5.5. L45 CAPT. COOK HWY CARAVAN PARK REQUEST NEGOTIATED DECISION

REPORT AUTHOR(S)	Jenny Elphinstone, Senior Planning Officer
GENERAL MANAGER	Nick Wellwood, General Manager Operations
DEPARTMENT	Development Assessment and Coordination
PROPOSAL	Request for a Negotiated Decision Notice for a Caravan Park
APPLICANT	Fiona and Richard Hewitt C/- Urban Sync Pty Ltd PO BOX 2970 CAIRNS QLD 4870
LOCATION OF SITE	L45 Captain Cook Highway Port Douglas
PROPERTY	Lot 45 on SR835

TOWN PLANNING CONSIDERATIONS

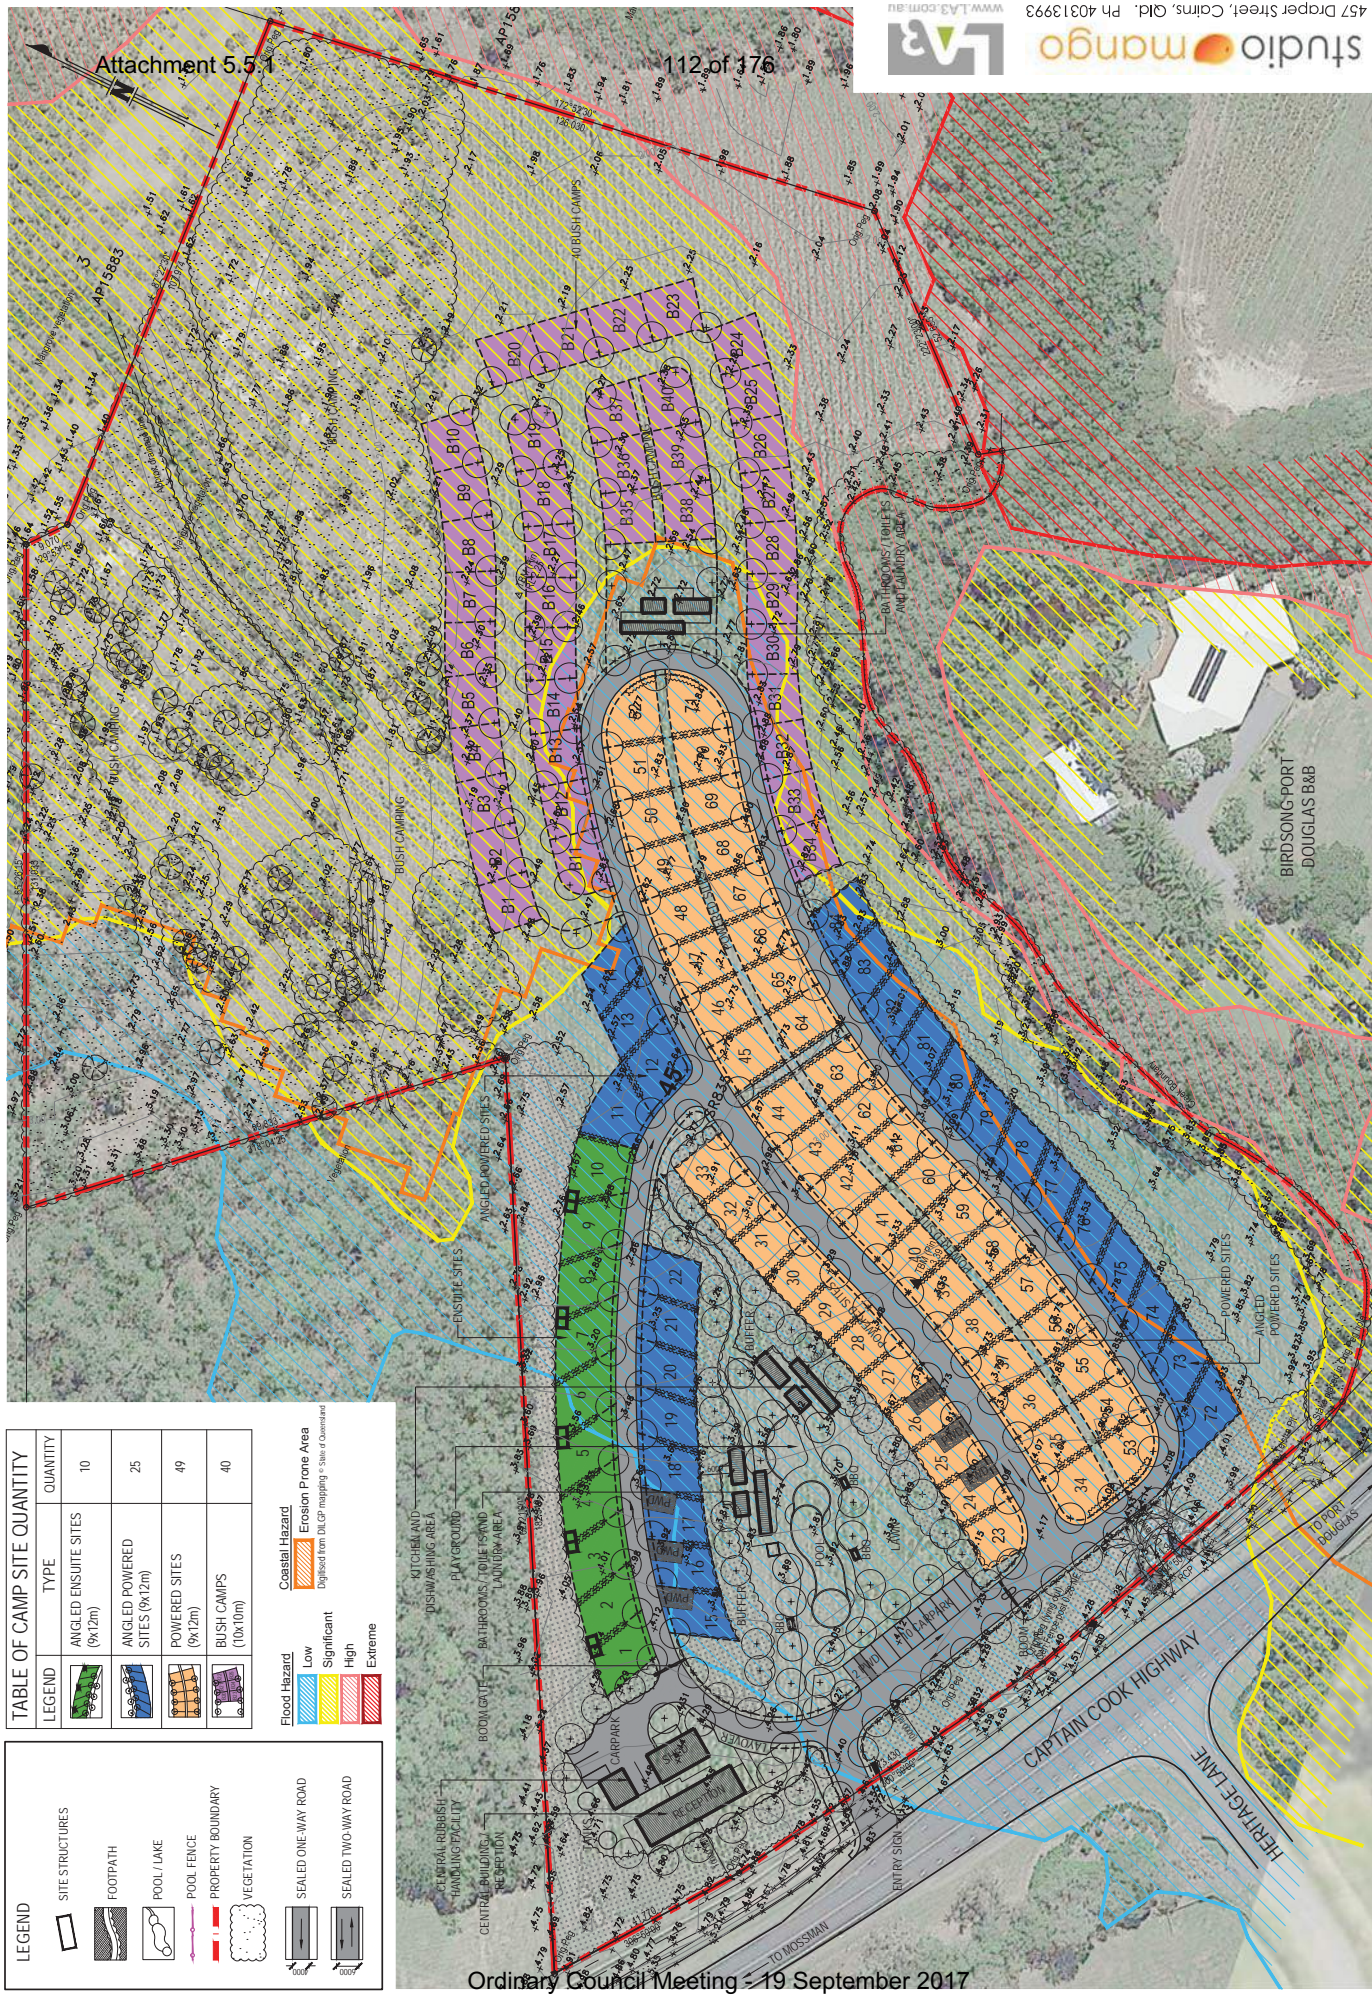
3. The proposed development must be amended to accommodate the following changes:
 - a. ~~remove wording of all individual "bush camping" sites from the plan other than the designated individual sites (B1 to B340 inclusive) on Drawing L-05 Revision 3 dated 12 December 2017 and L-03 Revision 3 dated 12 December 2016~~ Drawing L-02 Revision 4 dated 24/01/2017;

- b. ~~camping sites are to be as per the general layout of Drawing L-05 Revision 3 dated 12 December 2017 and L-03 Revision 3 dated 12 December 2016 and not as per Drawing L-02 Revision 4 dated 24 January 2017.~~

- h. ~~relocate powered sites 32 and 51 on (Drawing L-05 Revision 3 dated 12 December 2017 and L-03 Revision 3 dated 12 December 2016) at least 30m from the front boundary. This is also in reference to sites 23, 34 and 53 (on Drawing L-02 Revision 4 dated 24 January 2017) to be located at least 30 metres away from the front setback; and~~

- “Condition 3a: The plans referenced in this condition do not reference the approved plan noted in the ‘Approved Drawing(s) and/or Documents’ in the Decision Notice, of which is Drawing L-02 Revision 4 dated 24/01/2017, as was submitted with the response to Council’s Information Request. Additionally, in the response to Council’s Information Request, it was also clearly explained that the bush camping was to be spread out and not located on individual sites as per the plan. This was an error on our side and we acknowledged the plan would require amending in due course. We are agreeable to identifying a delineated area for the bush camping and a condition being imposed which limits the maximum number of camping sites to 40. This condition should be deleted as per the table above.*

- Condition 3b: This condition references the incorrect plan. This condition should be deleted in full.”*
- Condition 3c: This condition is vague and open to interpretation and does not need to be shown on a plan as the provisions being requested are conditioned under condition 36. This condition should be deleted in full.*

- Condition 3h: This condition references the incorrect plan and should be deleted in full.*
- Condition 3i: We do not believe it is reasonable to show this information on the DA drawings. This detail will be documented as part of the Operational Works*

Condition 3a: Clarification with the applicants identified that the wording of the "bush camping" in the expansive areas was incorrect. There was opportunity for the applicant to amend the submitted plans prior to the public notification, or alternatively amend and re-notify the application. The plan lodged in response to Council's request for further information nominates the bush camping sites immediately adjacent to existing vegetation and this lack of setback is unacceptable and these additional sites are not supported. Significant concern is held with the spreading out of the bush camping sites in the low lying areas and the impact on the land. There is a requirement that ablution facilities be located at particular minimum distances from camping sites and this would not be achieved where the sites were not contained to a particular area. The condition is considered reasonable and relevant, reflects Council's consideration of the development as a whole and concern for the low lying areas.

Conditions 3b, 3f, 3g, 3h and 3i: The master plan needs to reflect the conditions and requirements of the approval. The applicant chose to amend only one of the three plans that were lodged for the development. This creates confusion as the plans vary in layout. A copy of the site plans submitted with the application is included in Attachment 1. Referral to a particular plan clarifies the extent of approval issued.

The plan lodged as a response to the request for information is the least desirable layout. Clarification with the applicant identified that there was no intention for bush camping to be spread out over the low lying area at the rear of the property.

A. That Council supports in part, the request for a negotiated decision for a Caravan Park on land described as Lot 45 on SR835, located at L45 Captain Cook Highway, Port Douglas, whereby:

i. Condition 3, Amendment to Design, is amended with the following additional part:

j. Inclusion of the staging plan being:

Stage 1: Entrance, external works (access, water and sewer etc.), reception, car park, pool, and central park area, inclusive of bbq's, bathrooms/toilets and laundry area, kitchen and dishwashing area, signage, sites 1-10, 29, 11-18, 19-28 and 33 to 43, the internal loop driveway adjacent to sites 1-10, 29, 11-18, 19-28 and 33 to 43, and all necessary, associated, internal infrastructure and landscaping; and
